E.J. Nist Family Park City of Normandy Park

RE: Nist Memorial Design

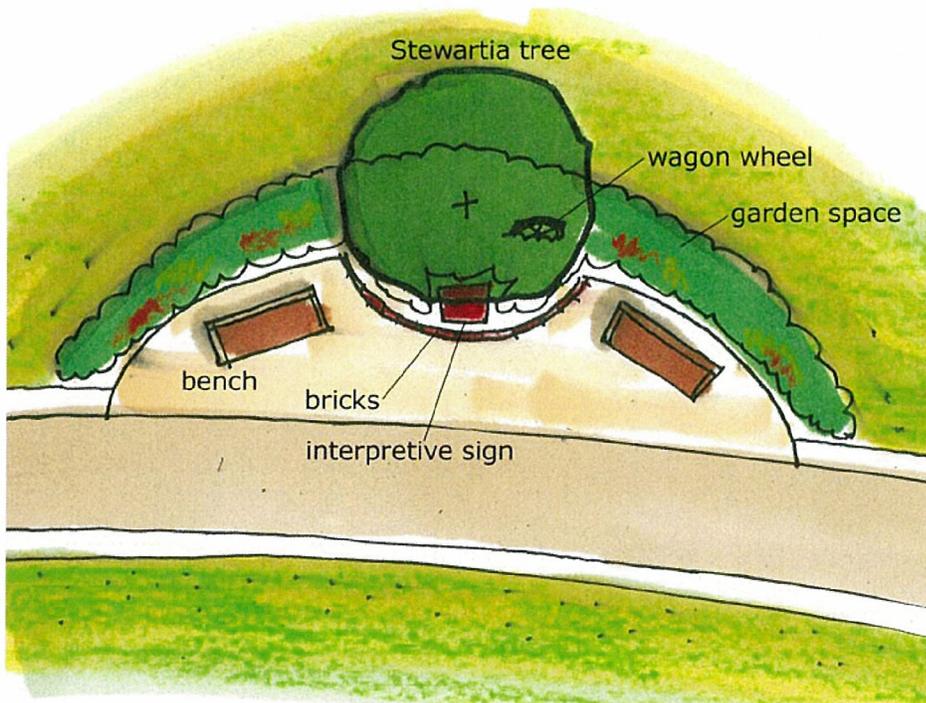
Option 1: We are concerned about the proposed location between E and N on the site plan due to conflicts with the future construction access for the plaza, shelter, and play area. As an alternate location, we suggest locating the memorial at the sunset view seating area. The following sketch plan shows a reflective space with an 18" x 24" interpretive sign of Emmet Nist's life. The bricks are shown at the edge of the pavement just in front of the interpretive sign and the wagon wheel could be buried half-way into the ground within the garden space behind. The garden space could be a rose garden or a selection of low-maintenance, drought tolerant shrubs and perennials. For the tree, we suggest relocating the Stewartia which is within the proposed playground area.
